ADDENDUM NO. 3

Date: **March 2, 2023**
Issued by: **Sacramento City Unified School District**
Project: **Project #0410-409 Albert Einstein MS Re-roof & Paint**

SHEET NO. A712

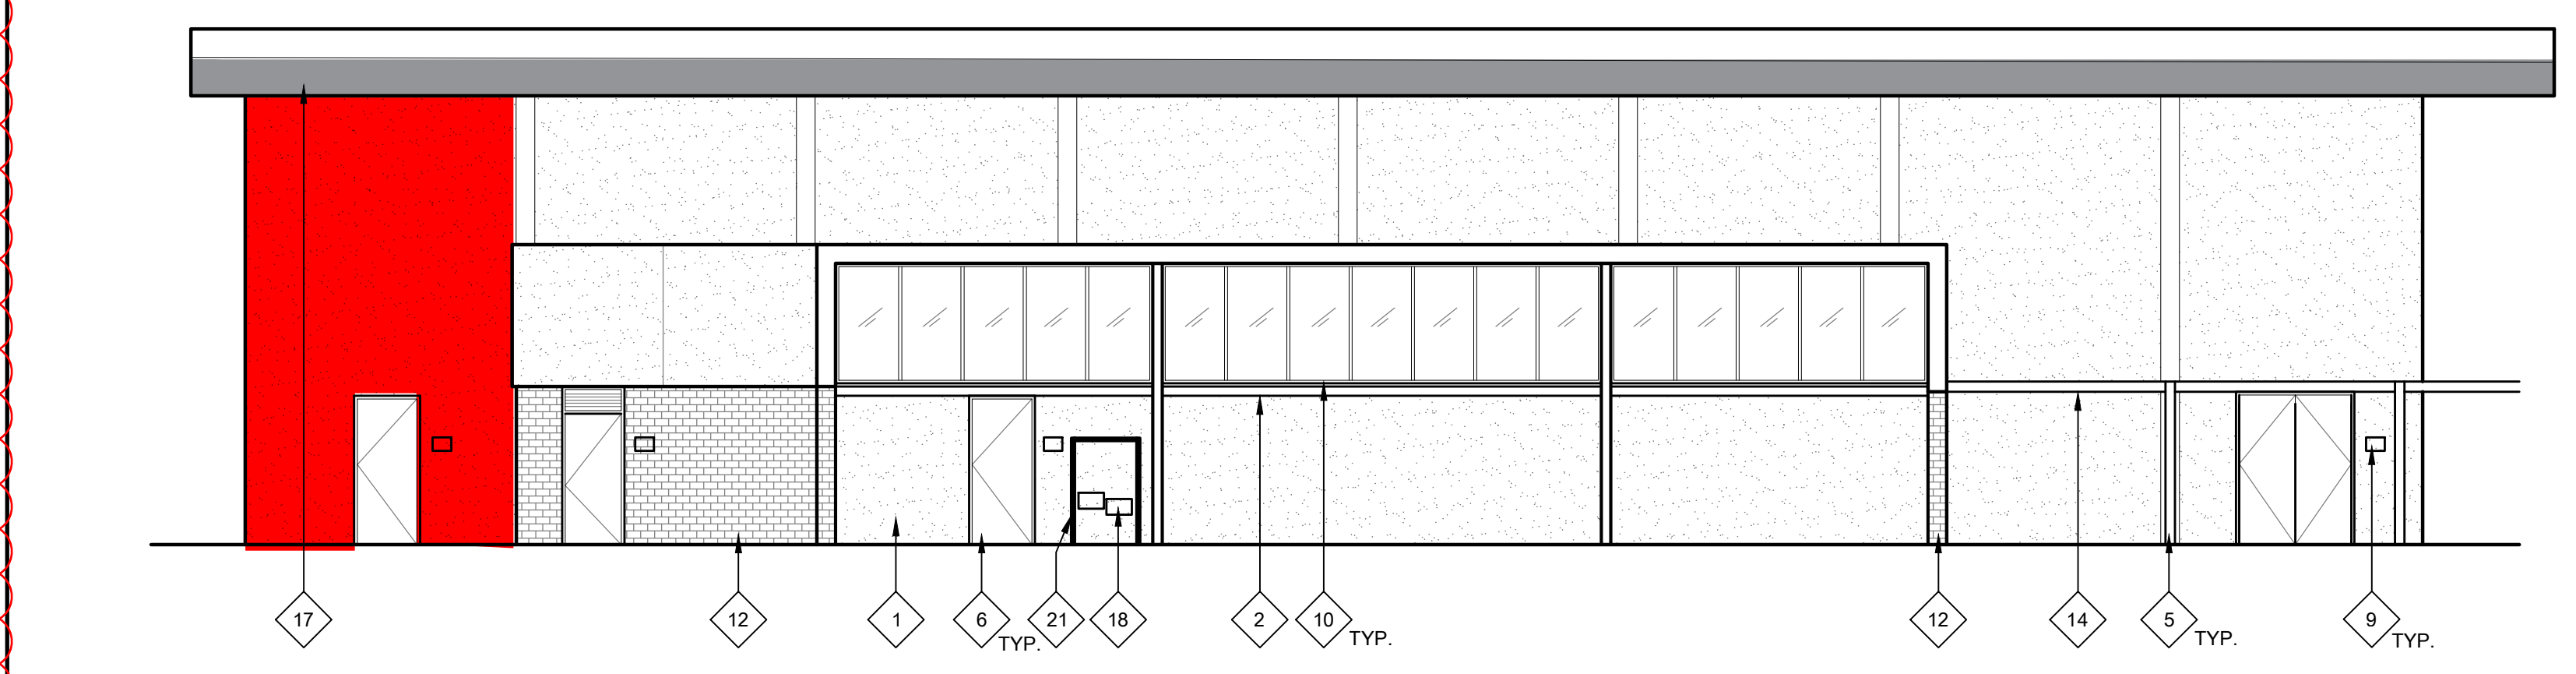
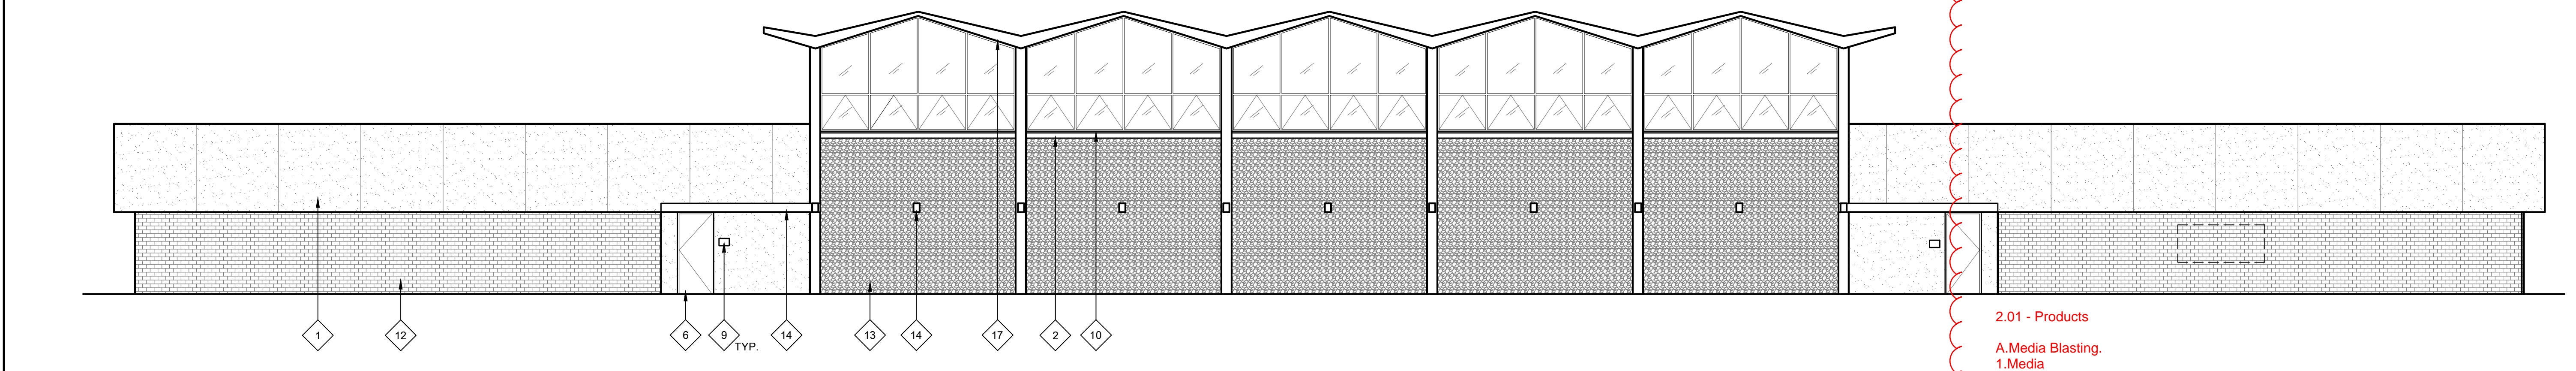
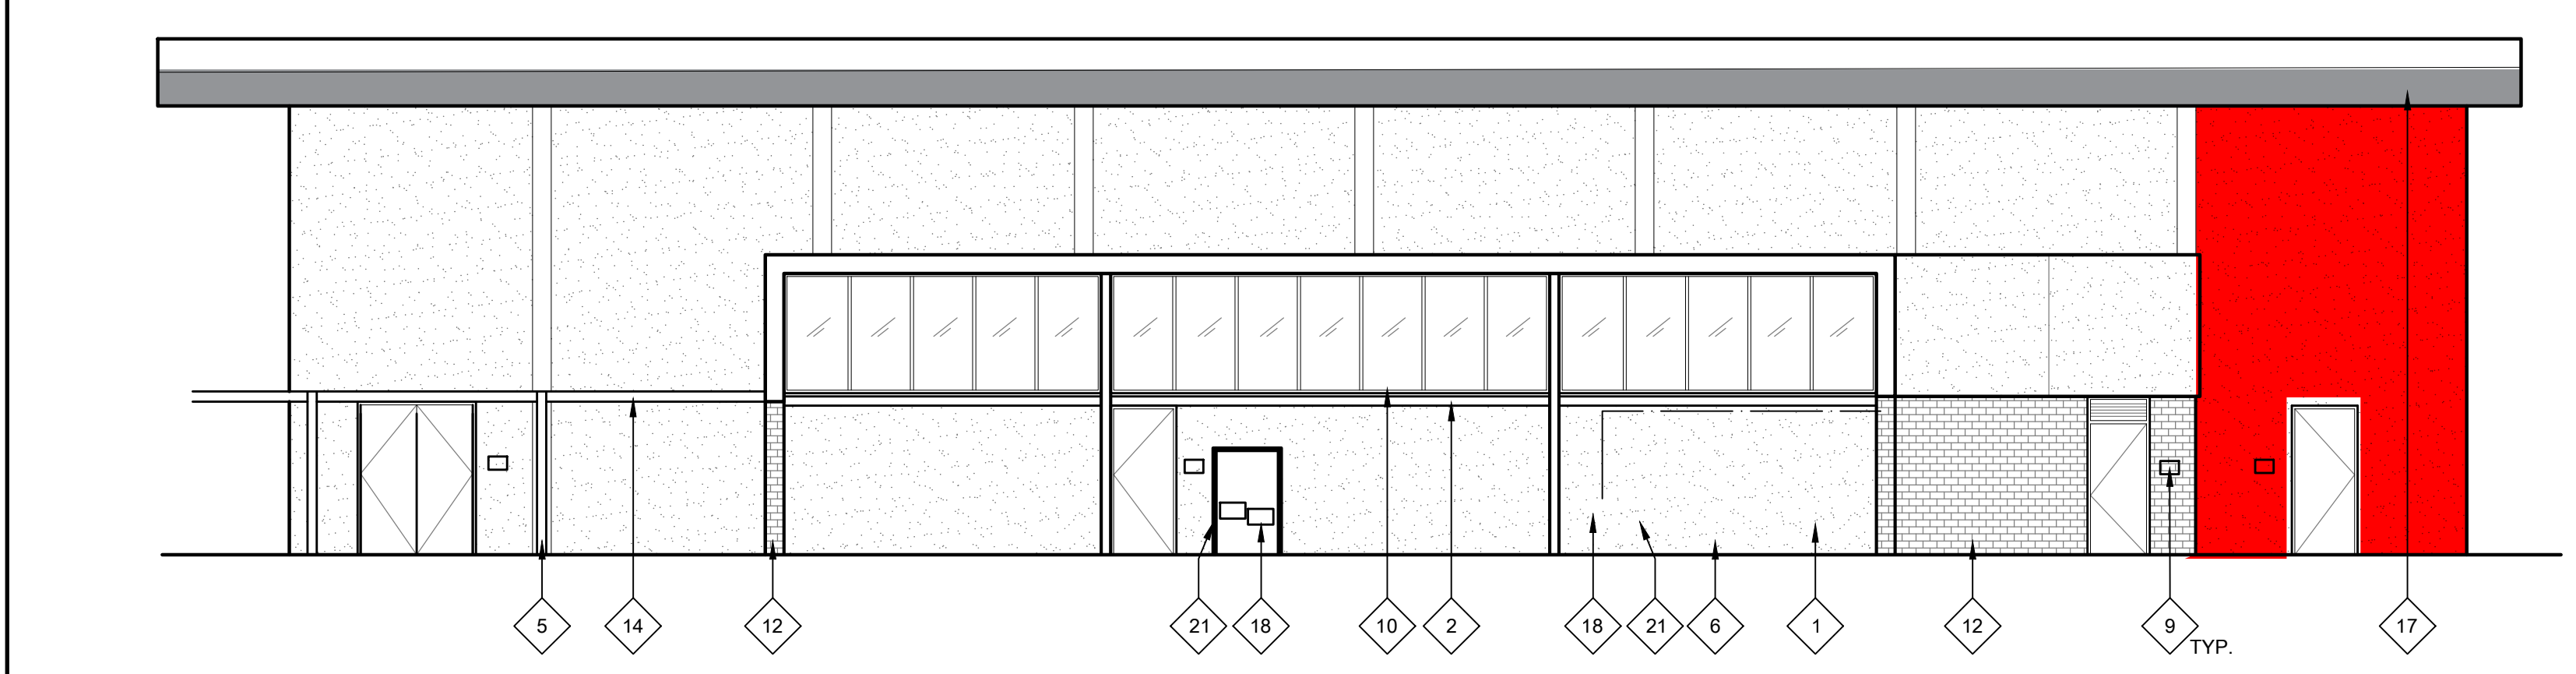
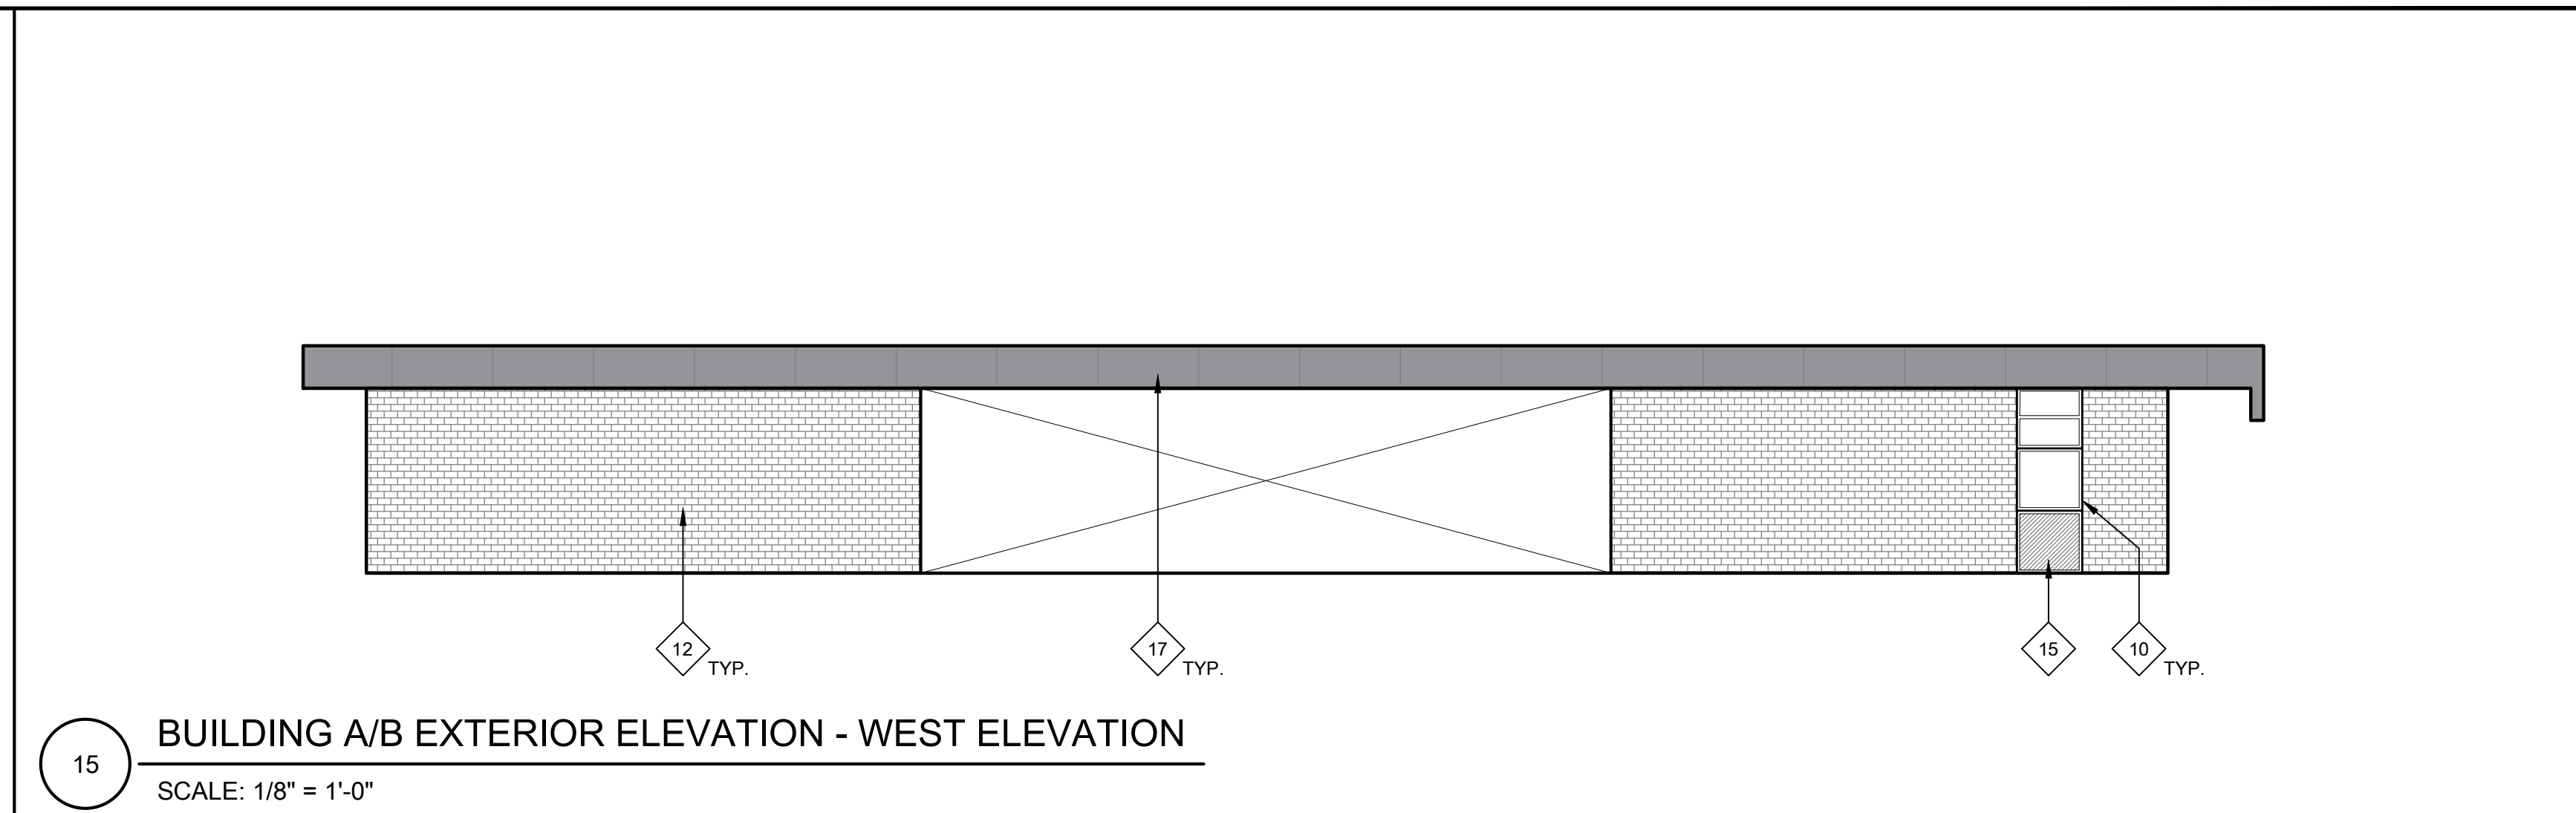
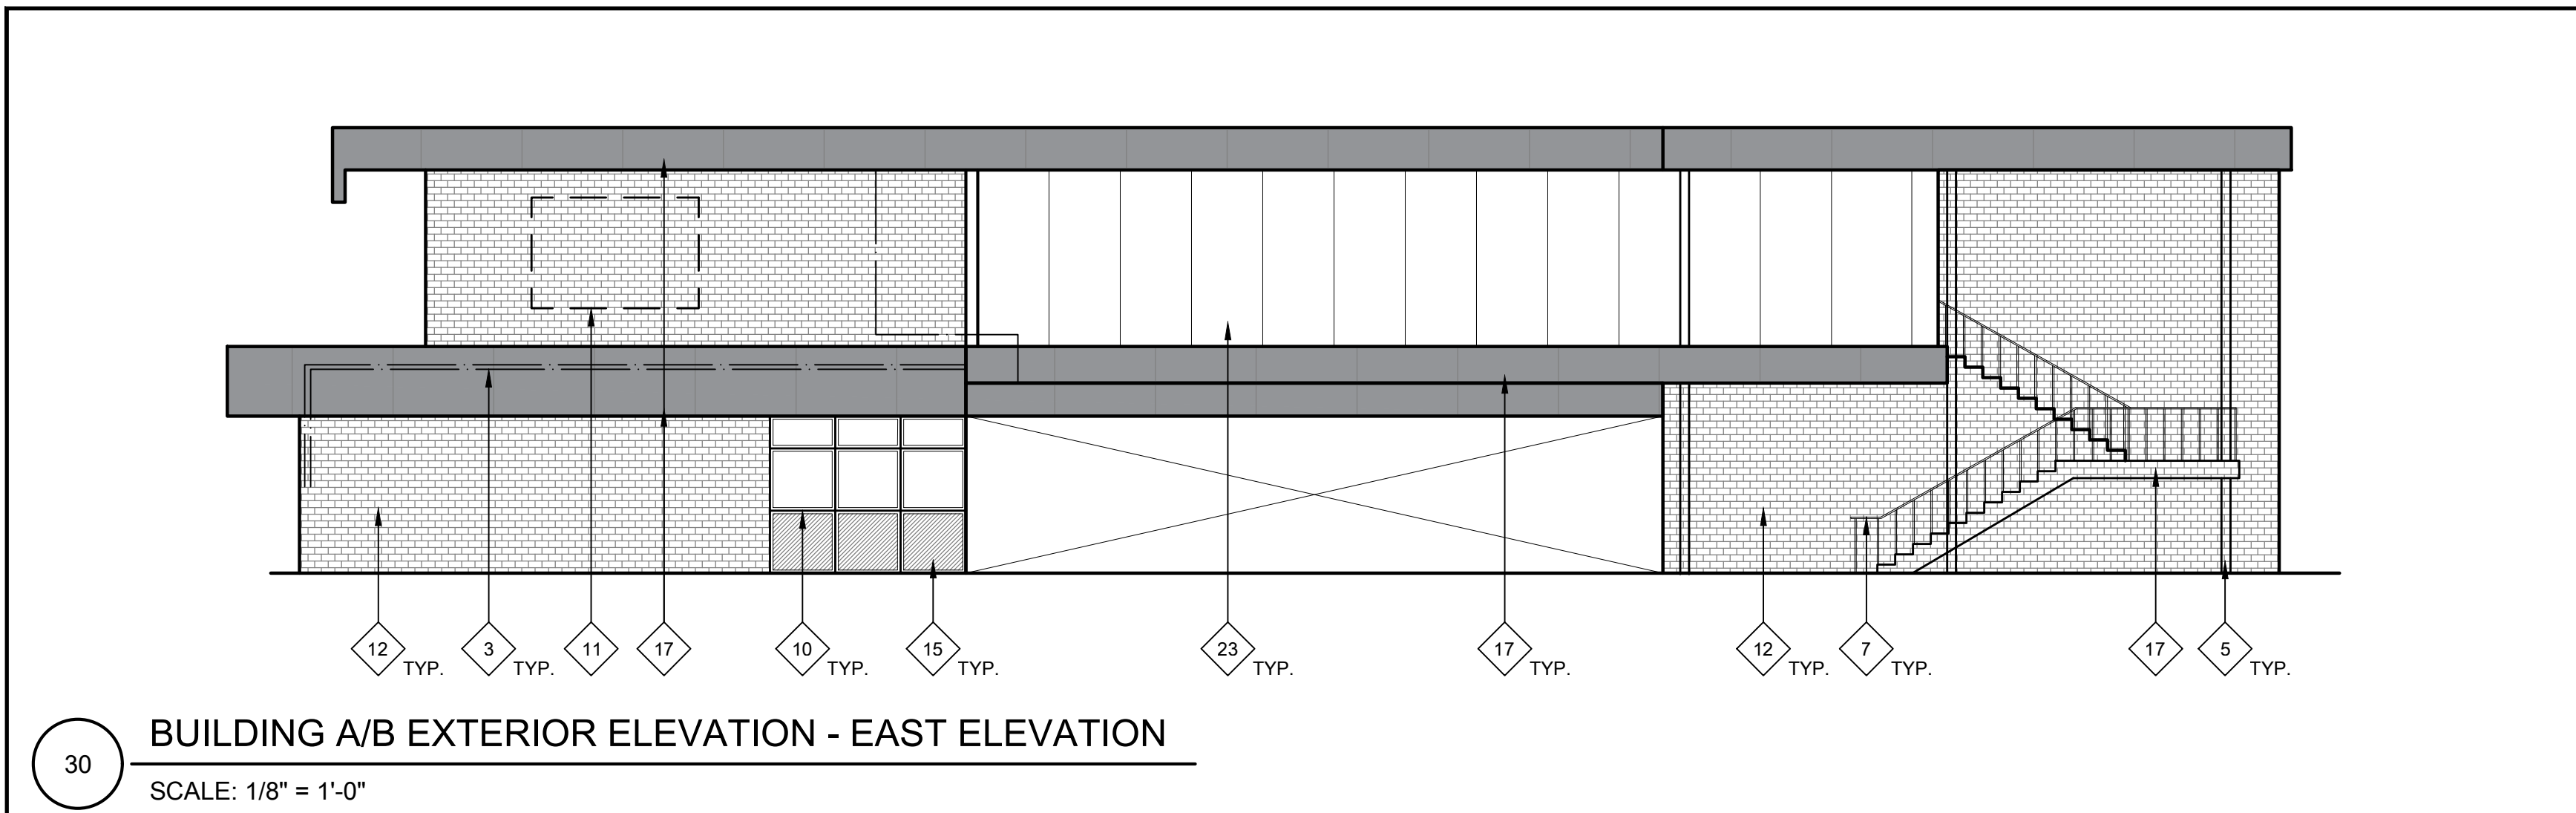
AD03.03 Sheet A712, Exterior Elevations, Building F: Revise wall prep at concrete walls to include media blasting down to bare concrete to remove flaking paint and provide "profile" on concrete wall surface. Prime and paint as described in Contract Documents. See attached sheet A712 with clouded areas.

Listed below are requirements for Media Blasting:

- Preconstruction Test Reports: For cleaning materials and methods.
 - Cleaning program.
 - Mock-up Panel
 - Provide a minimum 4 feet wide x 4 feet high section of concrete wall blasted and ready for painting.

- A. Media Blasting.**
- Media
 - Use sodium bicarbonate, nut shells, sand, or other material formulated for air or water blasting. Use least abrasive media as needed to remove existing paint down to bare concrete without damage to underlying concrete finish.
 - Maximum hardness: 2.5 on the Mohs hardness scale.
 - Products: Per manufacturer's recommendation. Subject to compliance with requirements and mock-up approval, provide the following:
 - ARMEX Maintenance XL media, with Suprakleen rinse accelerator, as manufactured by the Arm & Hammer company
 - Approved Equal.
 - Media additives
 - Use additives as required for flowability and rinse aids. Use additives by the media manufacturer, or approved by the media manufacturer.
 - Permitted dust suppressant for air blasting: Water.
 - Equipment
 - Provide and use equipment approved by the manufacturer for the designated applications.
